ADDENDUM NO. 1
TO
CONTRACT DOCUMENTS
AND
SPECIFICATIONS
FOR
TOWN OF VESTAL
MEMORIAL POOL RENOVATIONS PROJECT

CONTRACT NO. 1 – GENERAL CONSTRUCTION
CONTRACT NO. 2 – MECHANICAL CONSTRUCTION
CONTRACT NO. 3 – PLUMBING CONSTRUCTION
CONTRACT NO. 4 – ELECTRICAL CONSTRUCTION

Sheet Number: **C201R**

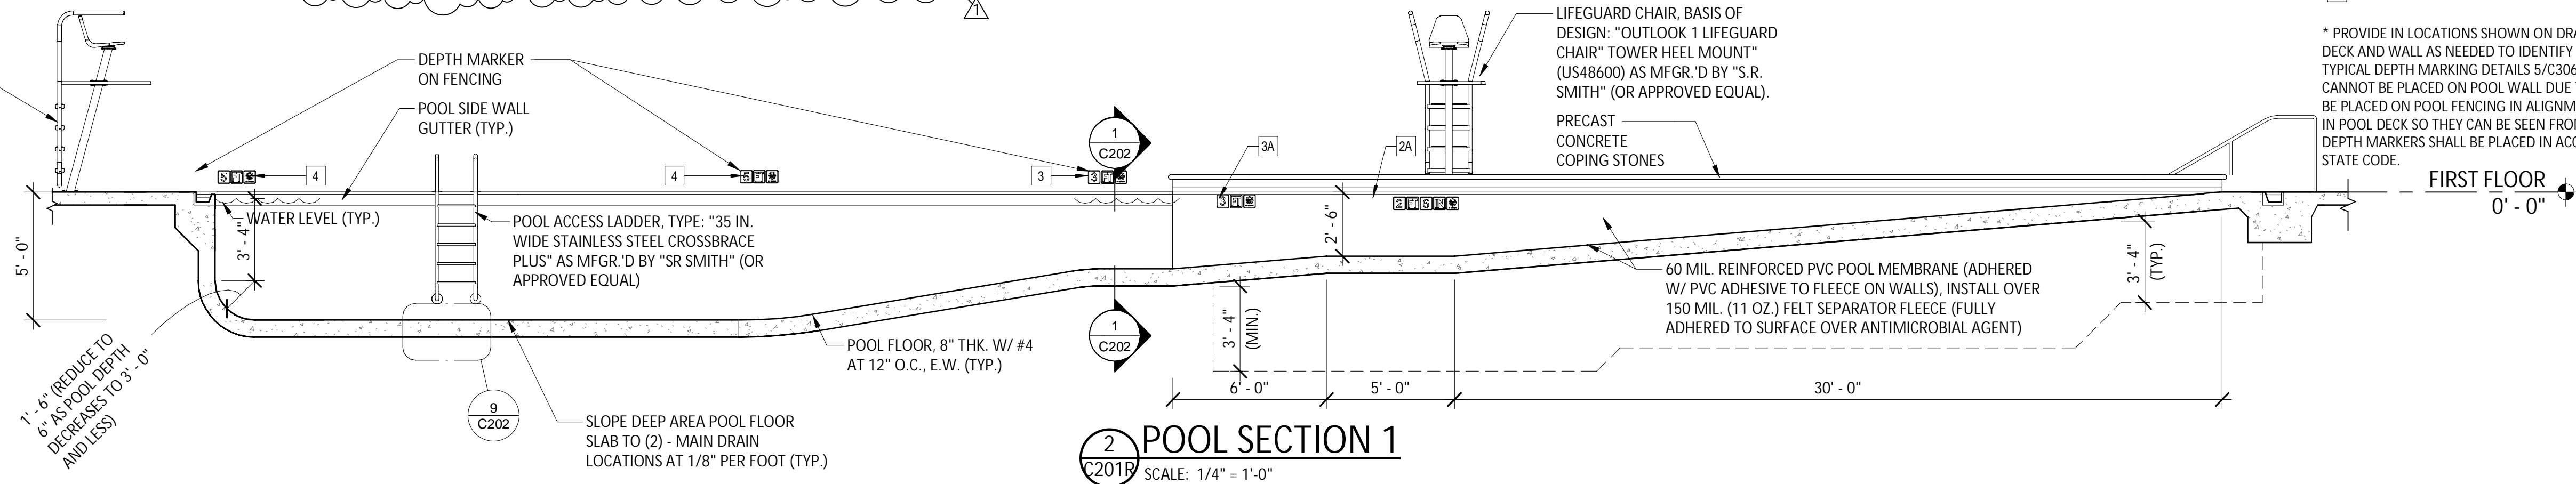
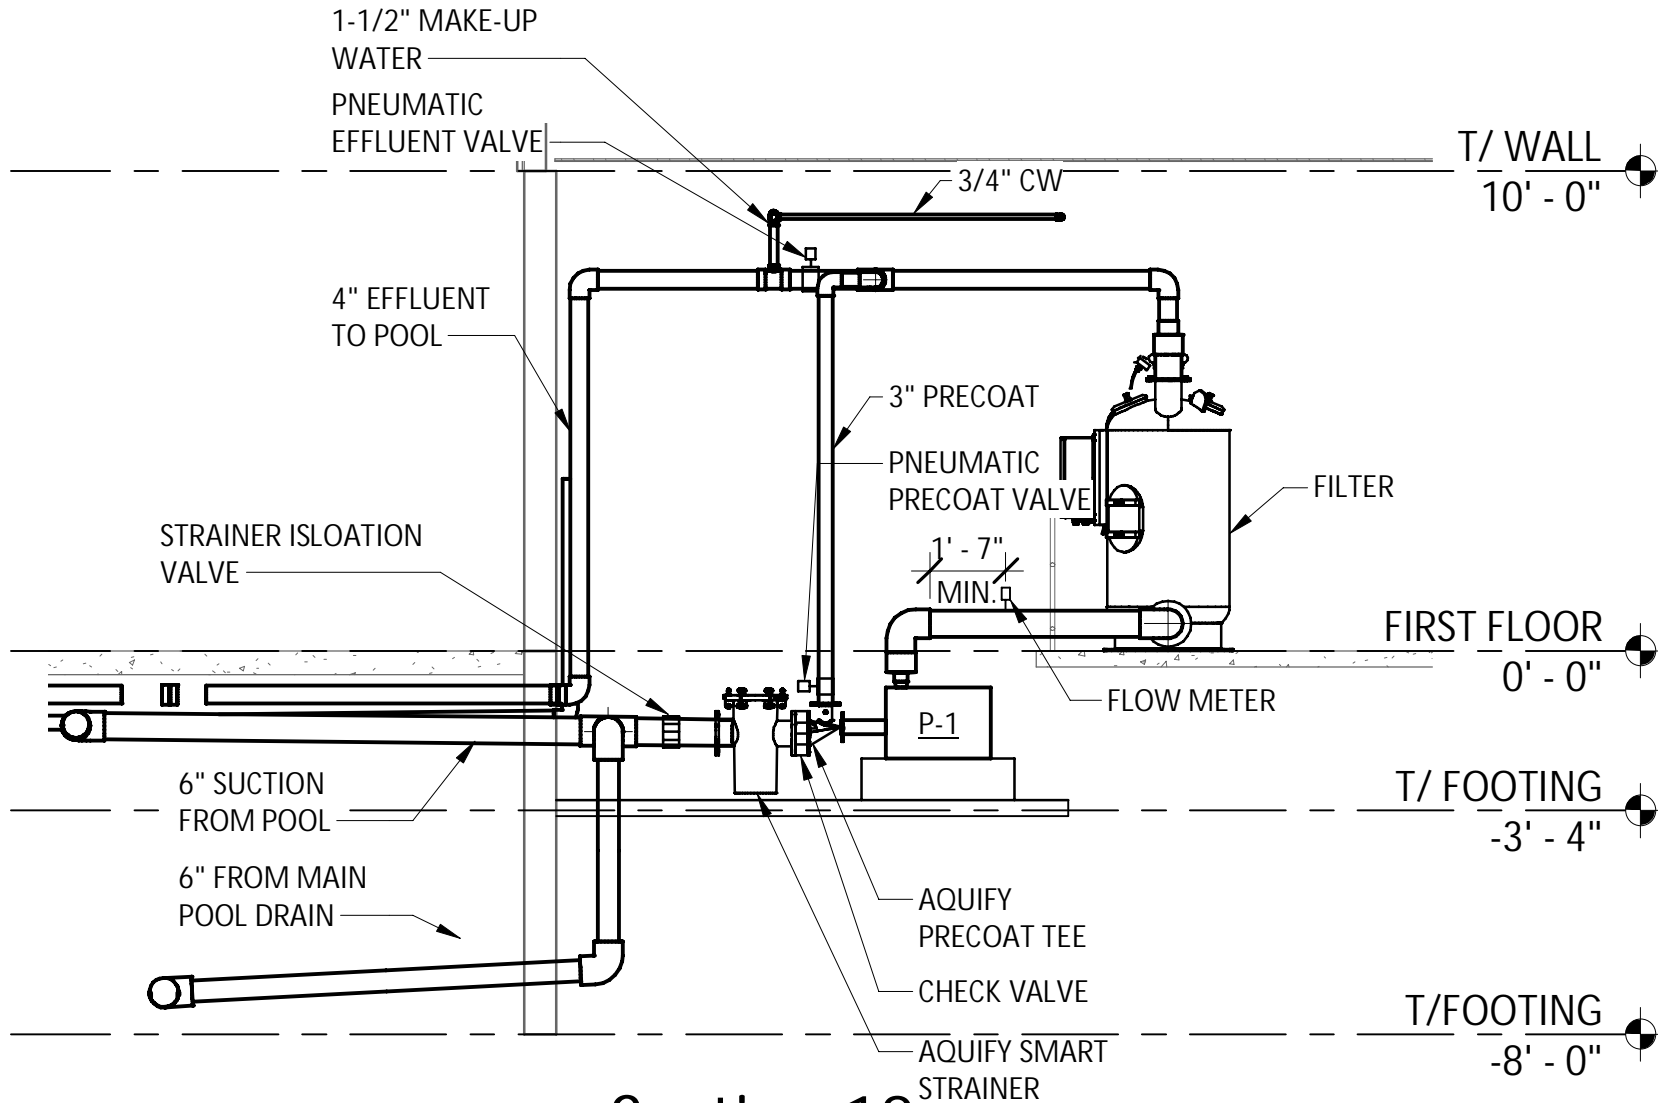
3. Reference: CONTRACT DRAWINGS – SHEET C201 – POOL ENLARGEMENT PLAN
 - a. DELETE Sheet C201 in its entirety and SUBSTITUTE THEREFOR Sheet C201R, as attached to this Addendum No. 1.

Figure Number
D-SK01

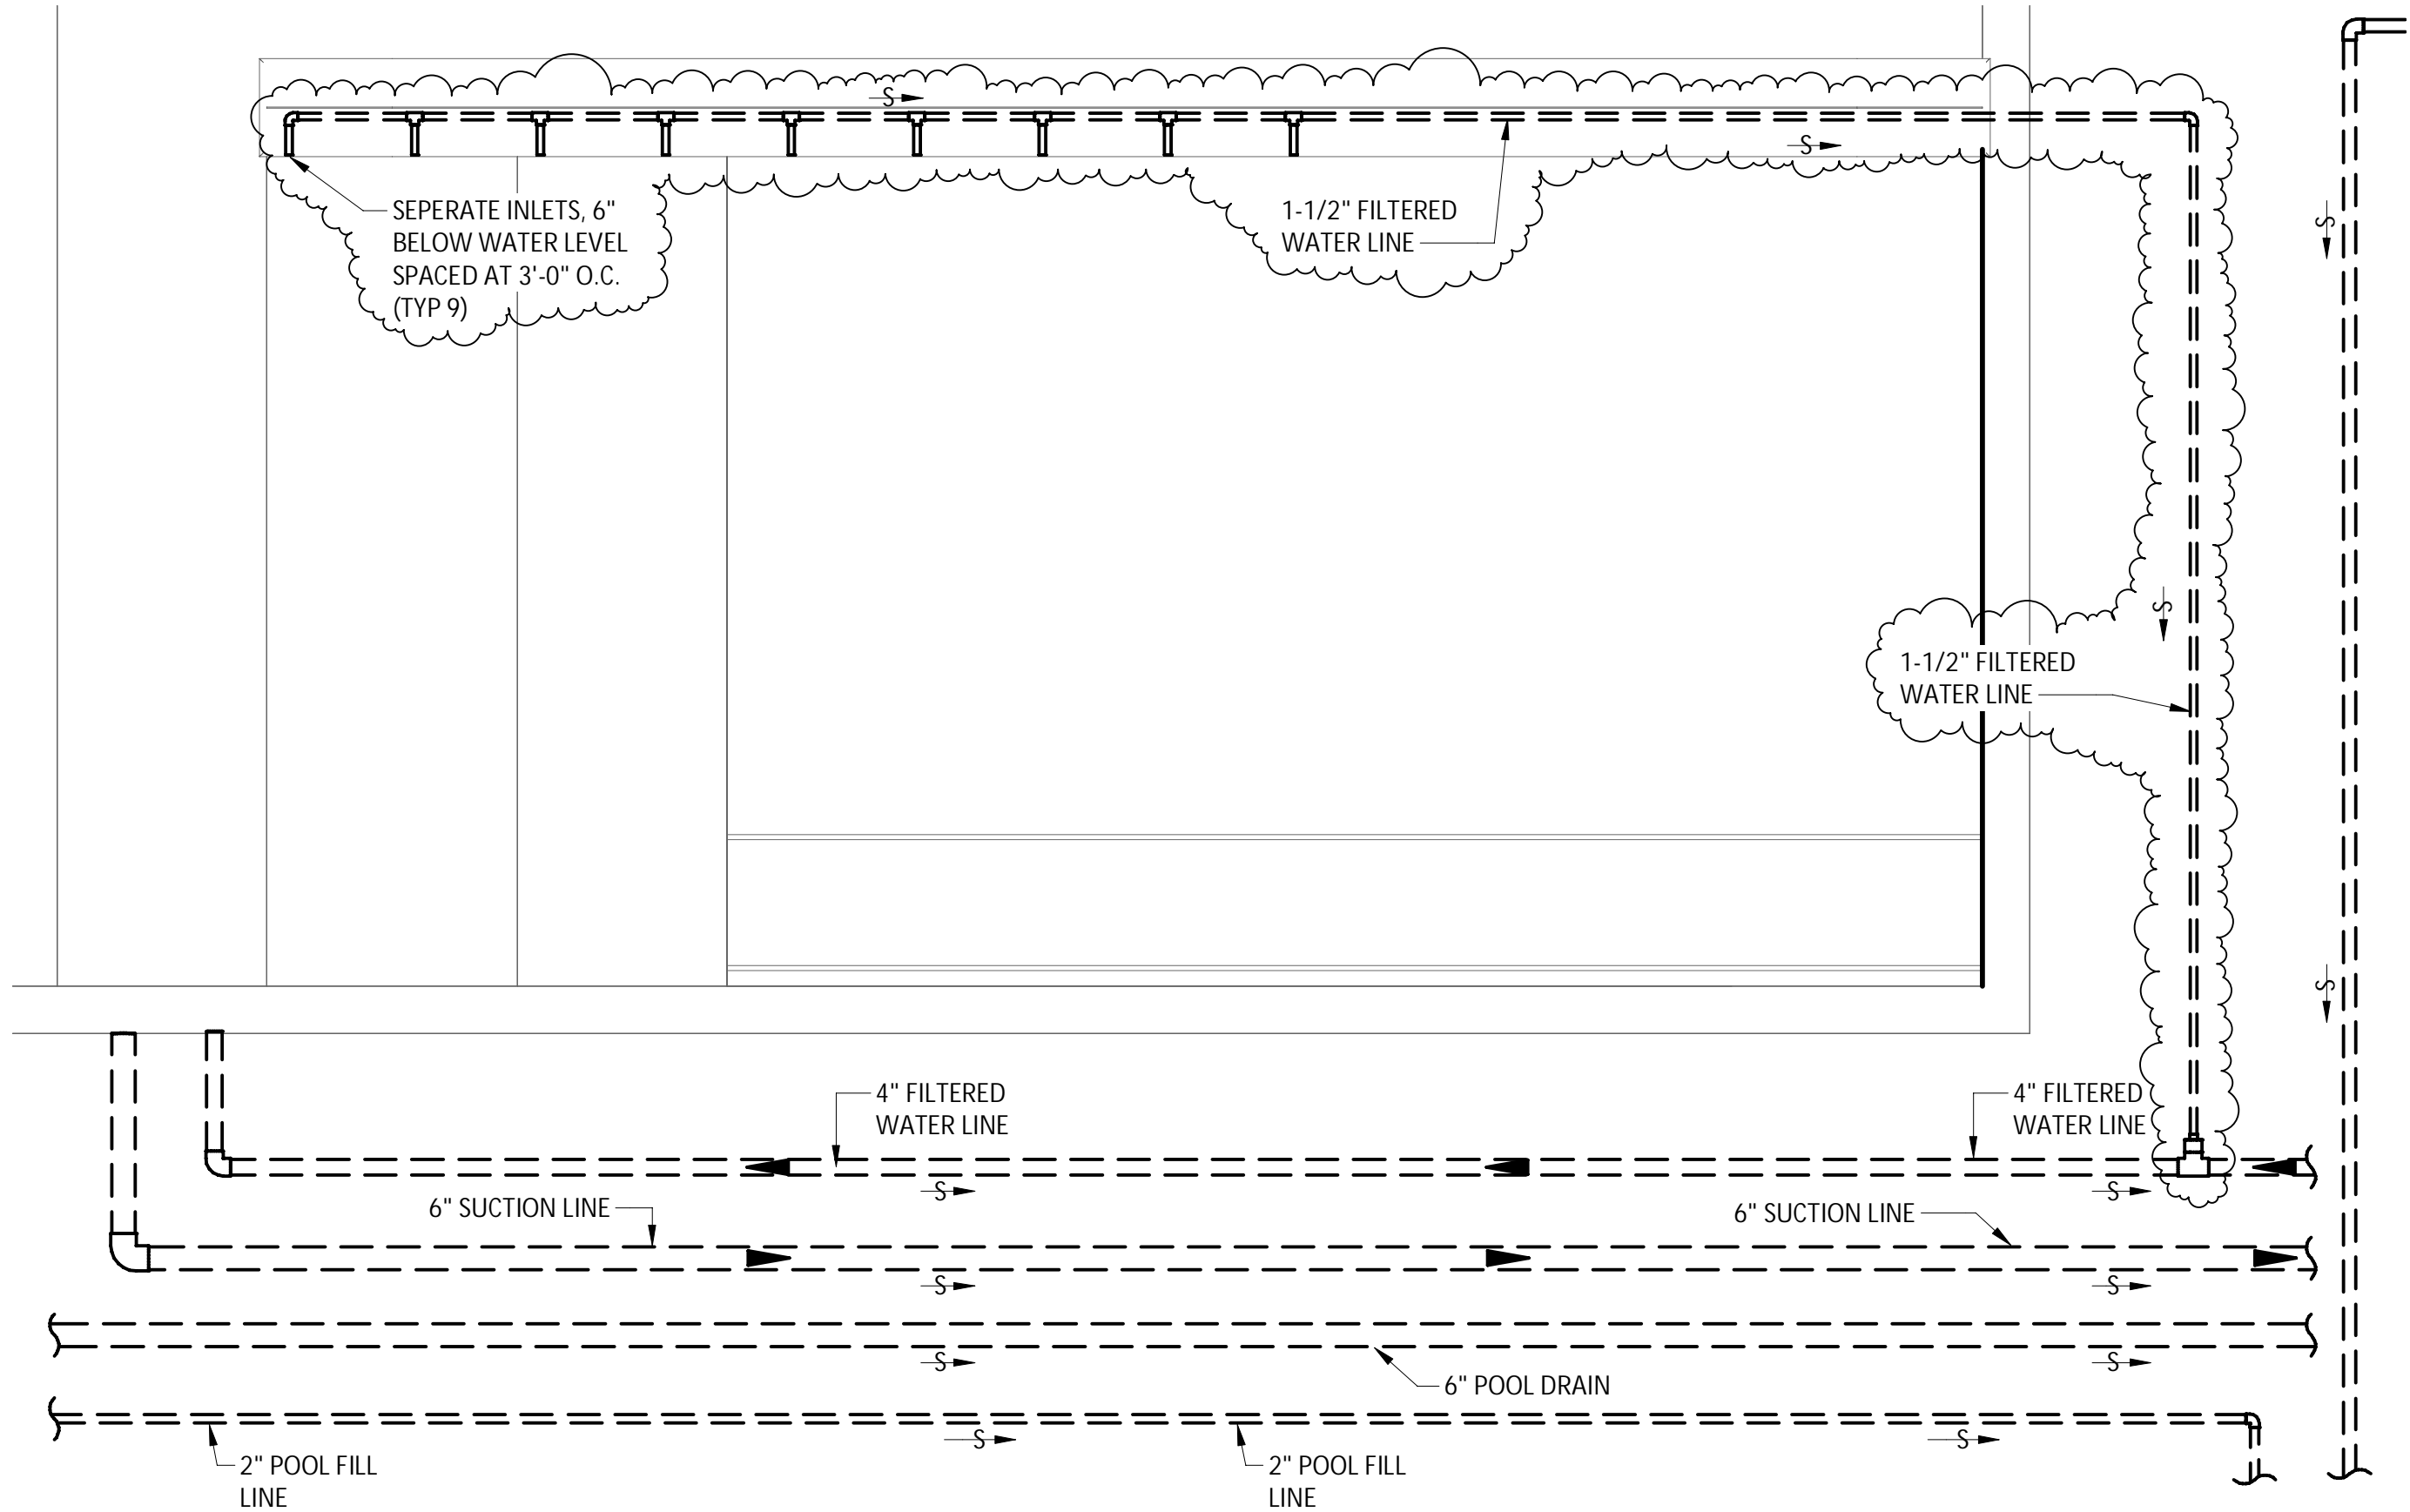
- b. Section 18, DELETE in its entirety, and SUBSTITUTE THEREFOR, Section 18 on Sketch D-SK01, as attached to this Addendum No. 1.
 - c. ADD 1-1/2-inch filtered water line and 3/8-inch orifice inlet fittings at 3’-0” on center along center wall of zero entry area as indicated on Sketch D-SK02.
